Medical Imaging Educators, Inc.

RE: Byproduct Material License
Thomas R. White, M.D.
Tri-State Cardiac Imaging, Inc.
Control Number 81246

In response to your letter dated June 27, 1986, I have made the following changes to Dr. White's of the application and have responded in duplicate to your questions:

Detail of Hot Lab- Dr. White

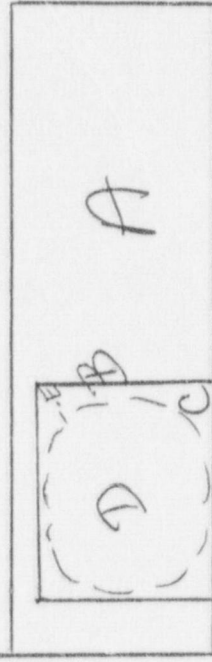
2. "Your facility diagram and description of equipment does not appear to be adequate for a Tc-99m generator. Please state where the generator will be stored, what type of shielding you will have around the generator in use, and a description of the decay-in-storage area where the spent generators will be stored prior to disposal".....

Please see the enclosed detailed diagram of the hot lab.

A. Receipt of Material

B. L shield- lead & lead glass

C. Generator- with lead Shield (sleve)

D. Preparation area- behind Shield

E. Waste Storage (Dis)

Below counter shielded
with 2"-3" of solid
concrete if necessary
to reduce exposure
